BALLANTYNE JSP20-38

Public Hearing at the request of Singh Development, LLC for approval of the Preliminary Site Plan, Woodland Use Permit, Wetland Use Permit, and Stormwater Management Plan. The subject property contains 50.86 acres and is located in Section 31, on the west side of Garfield Road, north of Eight Mile Road. The site is currently undeveloped. The applicant is proposing to construct 41 single-family residential units as part of a RUD Agreement with lots ranging in size from 21,780 square feet to 44,045 square feet.

PLAN REVIEW CENTER REPORT

Review Date: February 10, 2021
Review Type: Preliminary Site Plan
Project Name: JSP20-38 Ballantyne (2020)
Location: North of Eight Mile, West of Garfield Road; 22-31-400-007
Plan Date: April 16, 2014
Prepared by: Christian Carroll, Planner
Contact: E-mail: ccarroll@cityofnovi.org Phone: (248) 735-5607

SHEET 2

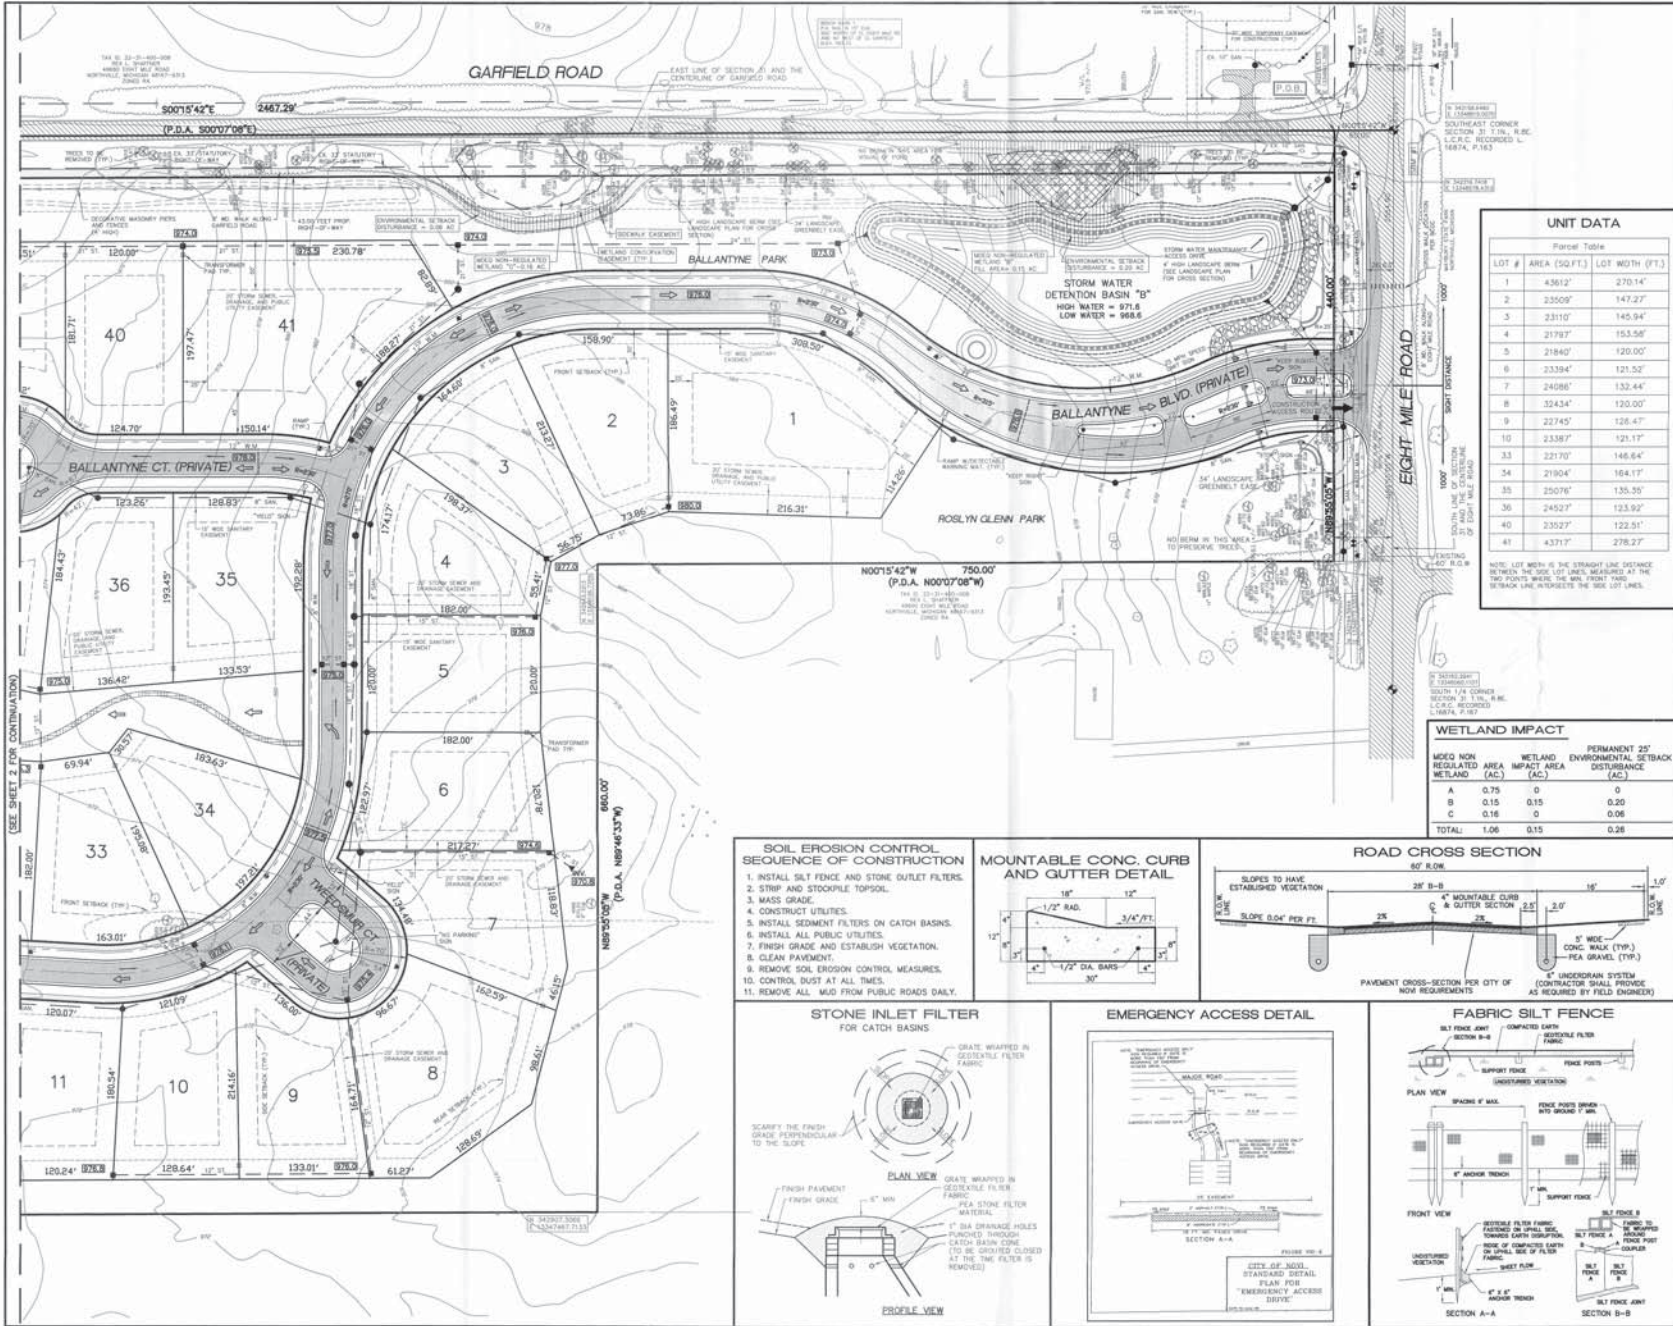
The observed conditions at the Site consisted of a gently rolling fallow farm field dominated by short herbaceous vegetation with about 2-inches of snow cover. Three wetland areas, Wetlands A, B, and C as shown on the Plan, were identified at the Site in topographic depressions and MSG concludes that the wetland mapping is mostly accurate. An apparent wetland delineation flag labeled C-12 observed at the Site, approximately corresponding to Wetland A delineation point A-10 on Sheet 2 of the Plan, in MSG's opinion should be moved 10-feet to the west.

3. The Natural Features Setback line is mislabeled on Sheet 2 of the Plan and should be corrected.
4. The City of Novi Wetland and Watercourse Protection Ordinance (Section 12-176 – Mitigation) states that design, construction plan and a monitoring plan must be approved for wetland mitigation projects. These items pertaining to specific impacts associated with the current plan need to be clarified on subsequent Plan submittals.

SHEET 4

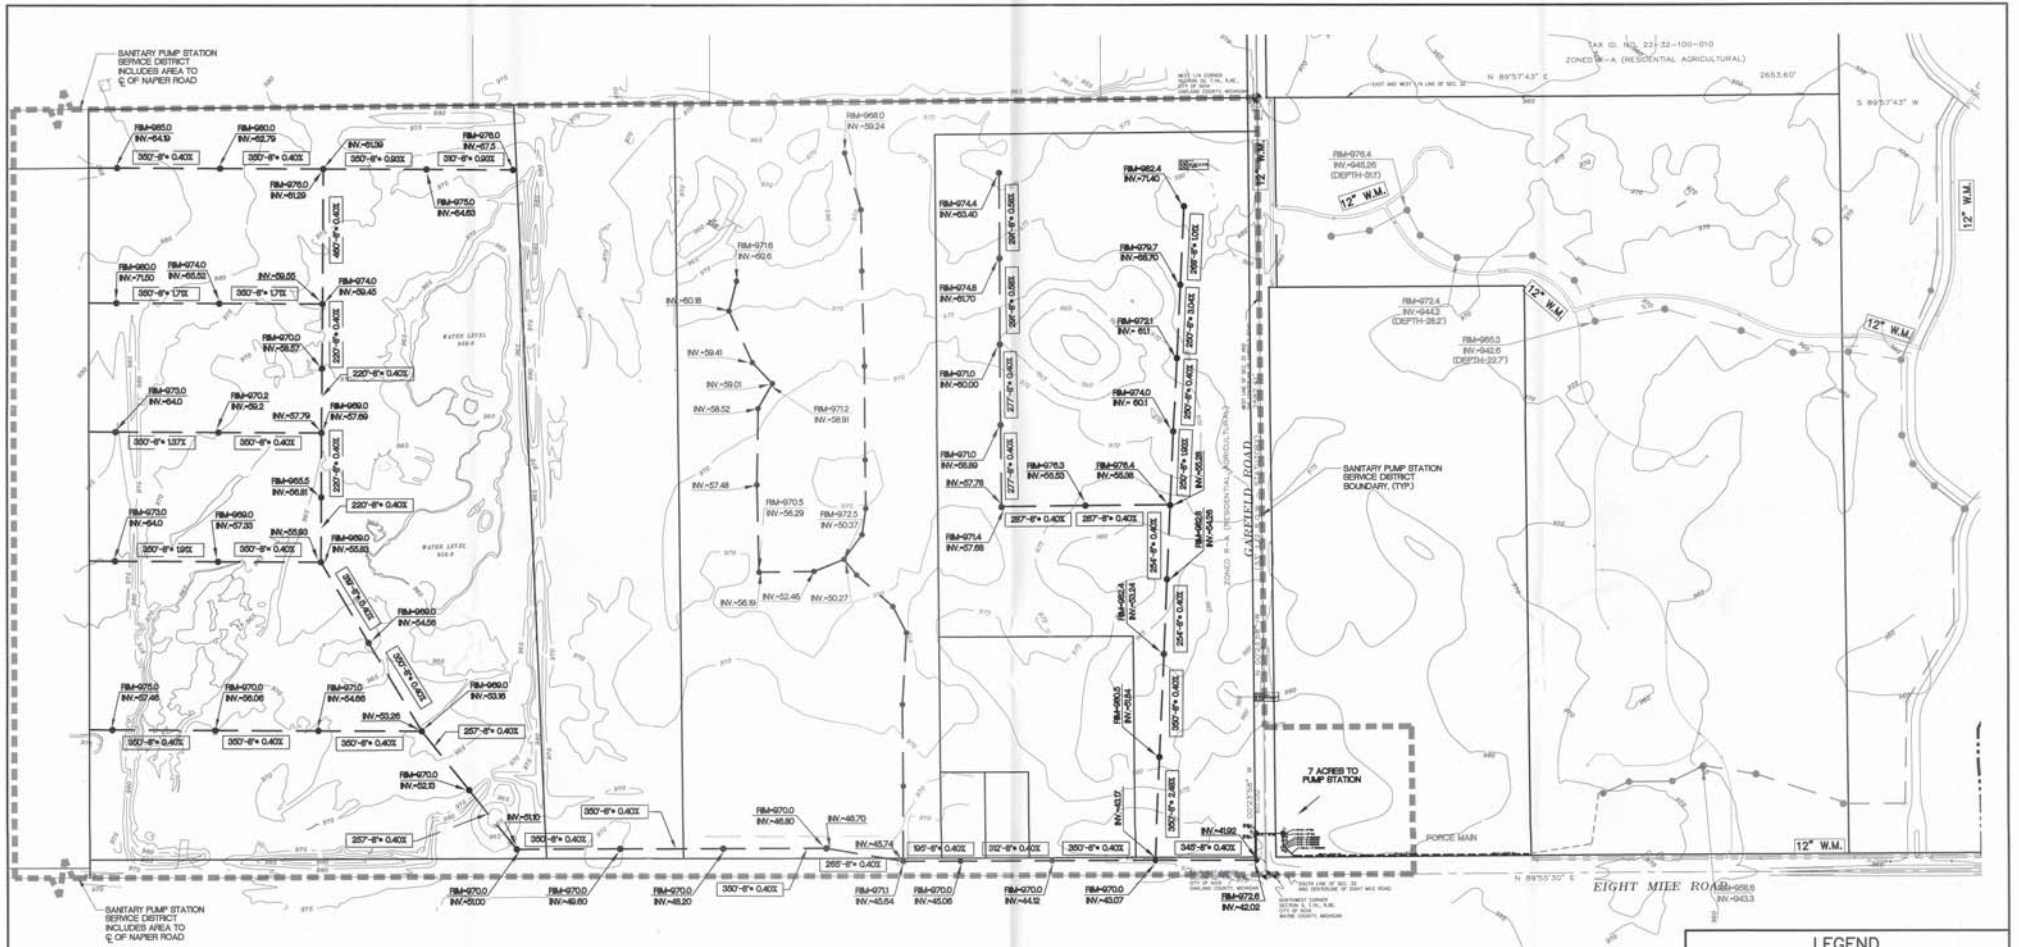
- water elevation). Show and note in both plan view and on the Detention Basin Sediment Filter Detail on sheet 4.
21. As part of the Storm Drainage Facility Maintenance Easement Agreement, provide an access easement for maintenance over the storm water detention system. Also, include an access easement to the detention area from the public road right-of-way.
